Indicates proposed changes to approved planning application 2019/6088/P and approved LBC 2019/6270/L

Client				
Kings Keeley Limited C/o Clearbell Capital LLP				
Project				
65 Kingsway - Base Scheme				
Title				
Demolition Basement Plan				
Status		Purpose of issue		RIBA stage
S2		For Planning		2
Project No.	Drawn	Checked	Scale	Rev.
1914	FB	TJ	1:100 @ A1 1:200 @ A3	P5

1914-BG-01-B1-DR-A-15.201

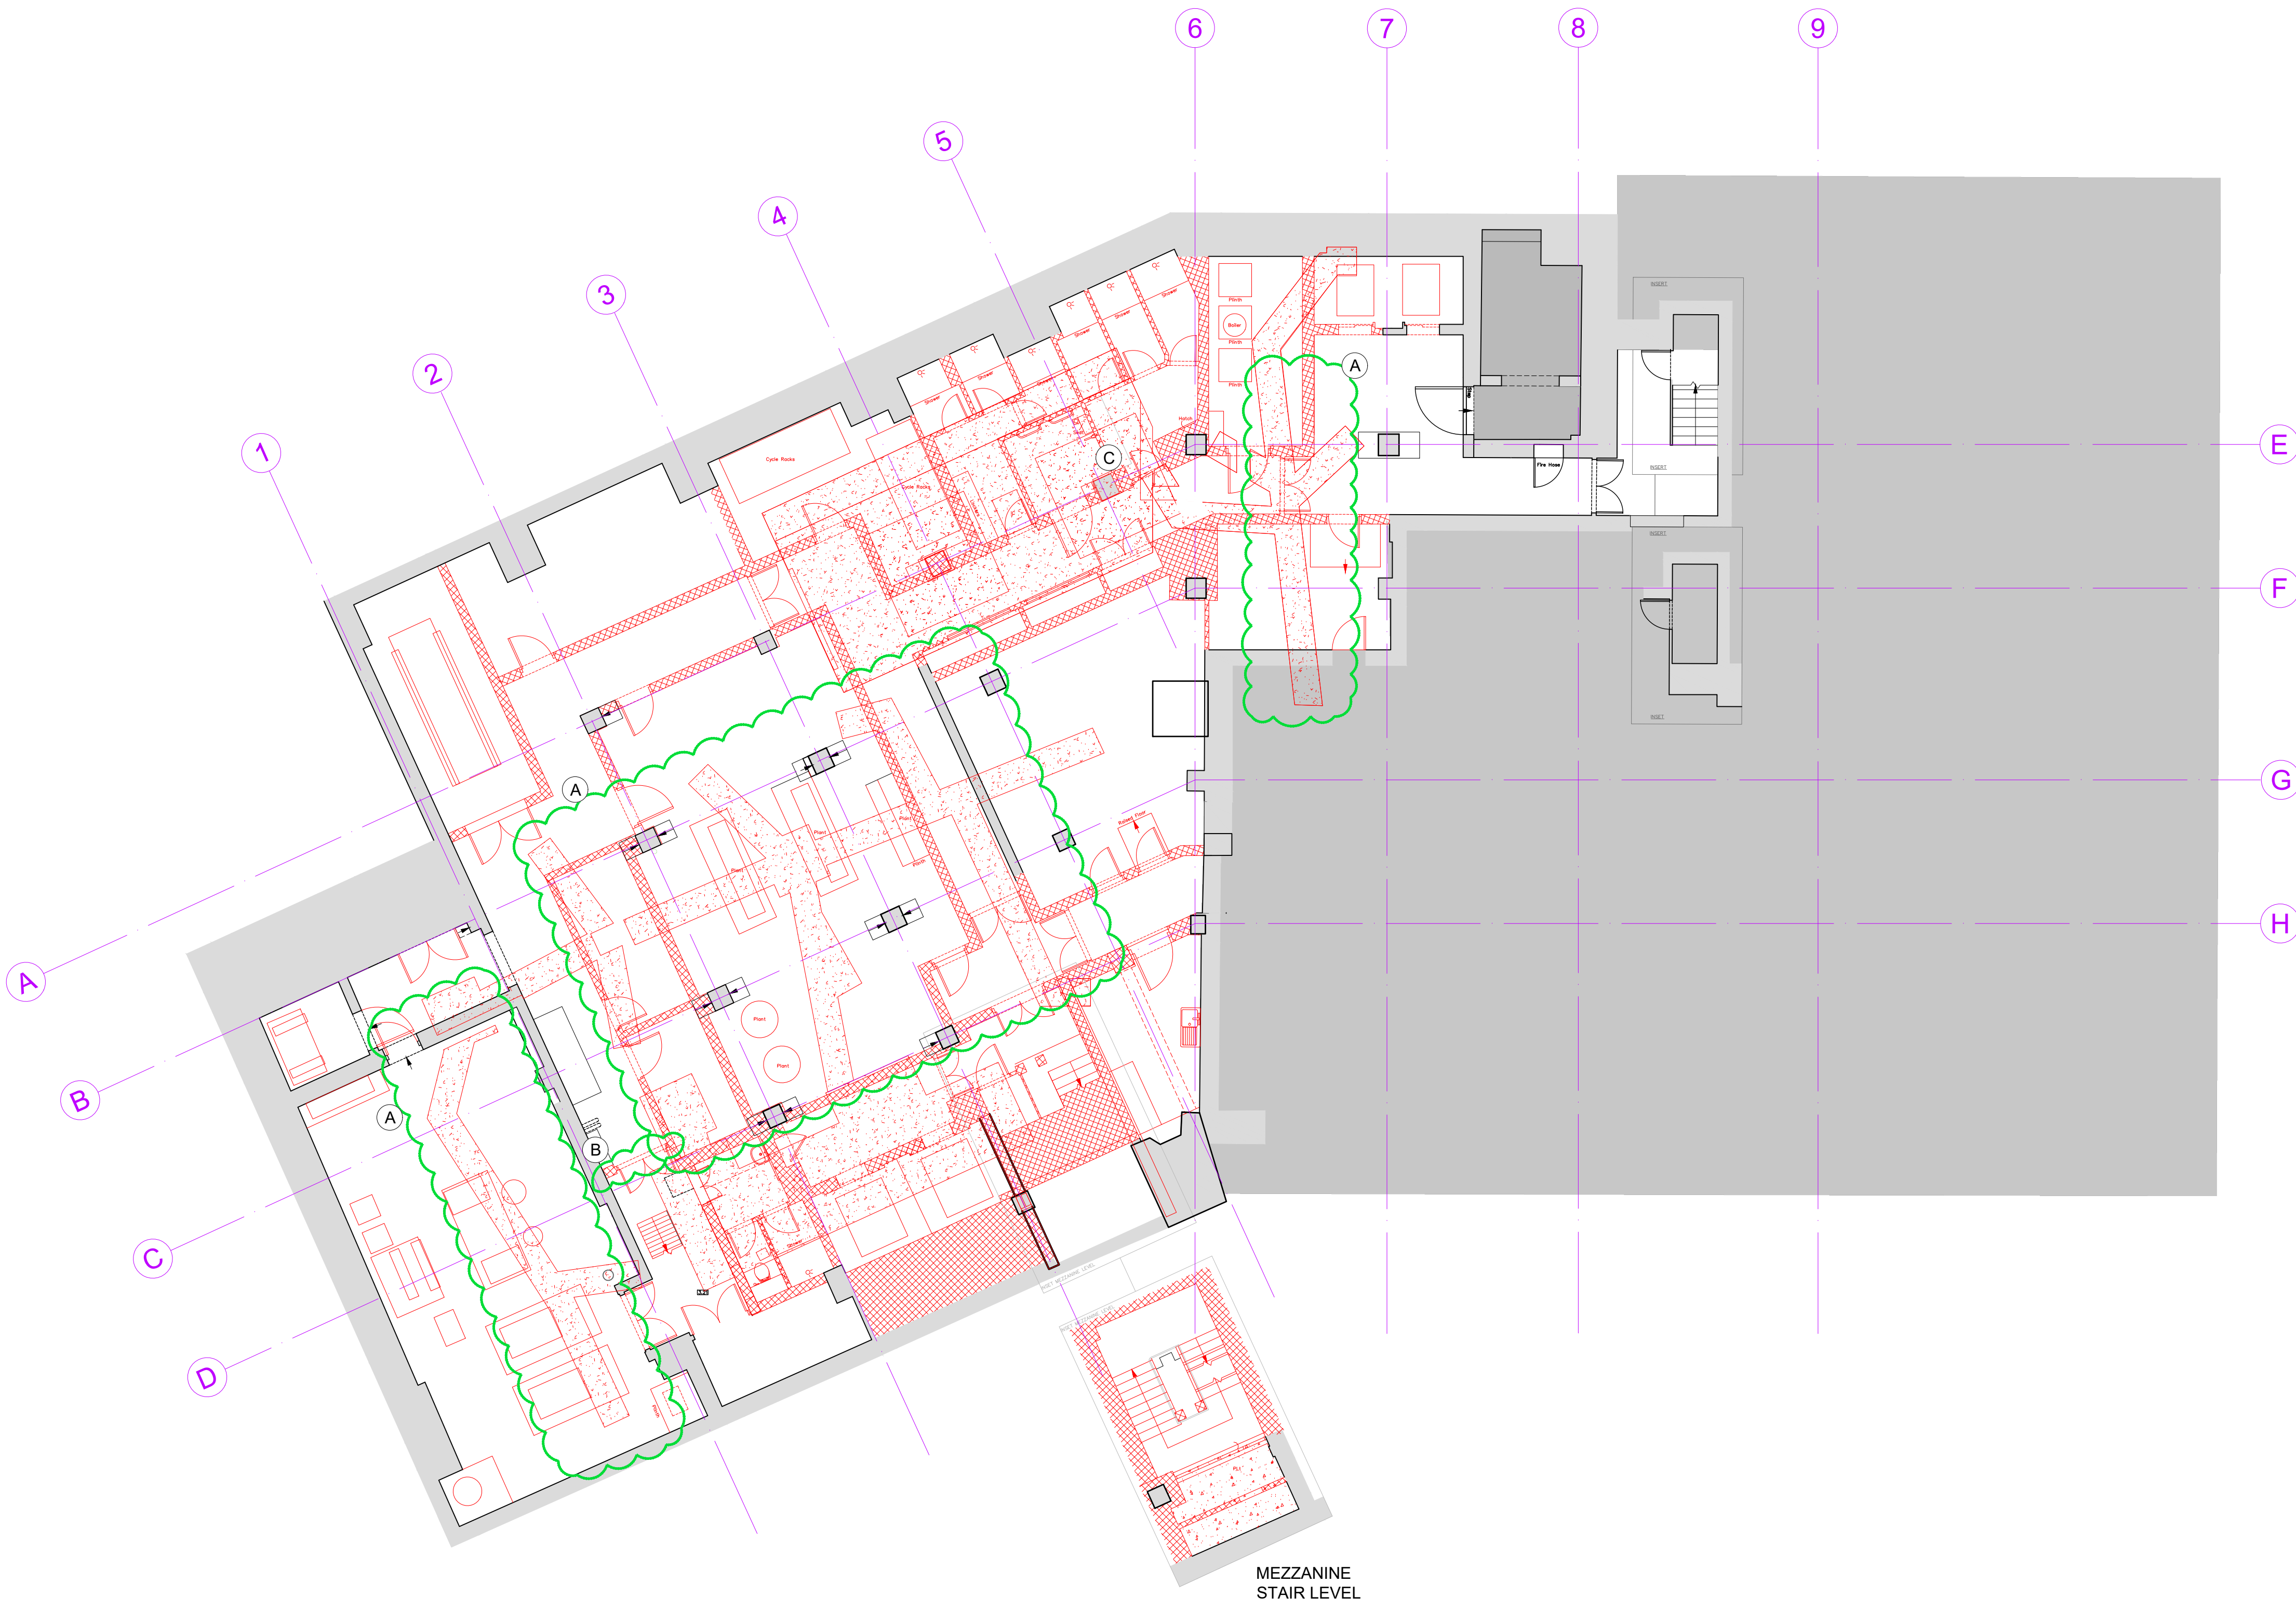
- A. Extent and location of slab demolition for drainage route amended to suit the locations of showers and toilets as per agreed BF layout
- B. Additional wall to be demolished required to suit new UKPN stair requirements
- C. Column on GL5/A retained
